REQUEST Current Zoning: RE-1(CD) (research, conditional) and INST(CD)

LOCATION Approximately 12.40 acres located along the south side of Mallard

SUMMARY OF PETITION The petition proposes up to 50,000 square feet of facilities to

STAFF RECOMMENDATION Staff recommends approval of this petition.

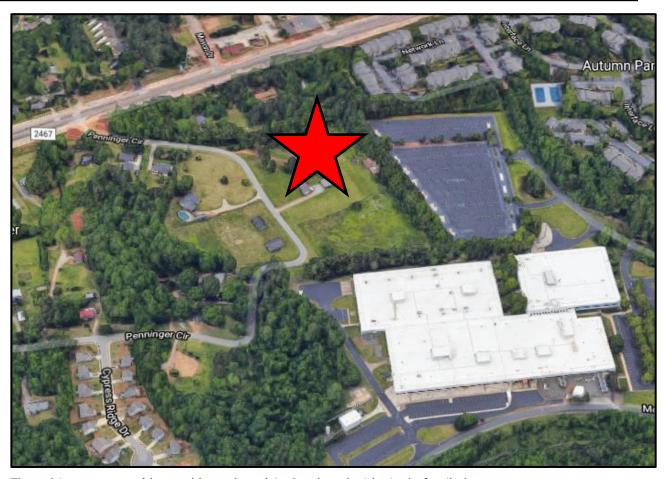
- 1.—The petitioner should revise the site plan and conditional note(s) to commit to construct curb and gutter along Penninger Circle per Chapter 19 of the City Ordinance. Please refer to the CLDSM USDG cross sections to determine the appropriate cross section for the curb line location. If only passenger vehicles will be using Penninger Circle, please refer to the Residential Wide cross section. The site plan should label and dimension both items from the back-of-curb and gutter and road centerline.

- a. Technical Clarification (site plan dated September 14, 2020): CDOT clarifies this request to revise proposed cross section A-A, to widen the existing roadway to the cross section provided for either USDG U-03A Local Residential Wide (if on-street parking is desired), or at a minimum, U-02 Local Residential Medium from the existing Penninger Circle Road centerline. This widening would improve the existing condition to properly handle two-way directional traffic, with the consideration to added traffic volume for this subject rezoning site. If larger design vehicles are planned to be routed to Penninger Circle, CDOT advises the petitioner to implement the USDG U-05A Local Office/Commercial Wide cross section. Addressed
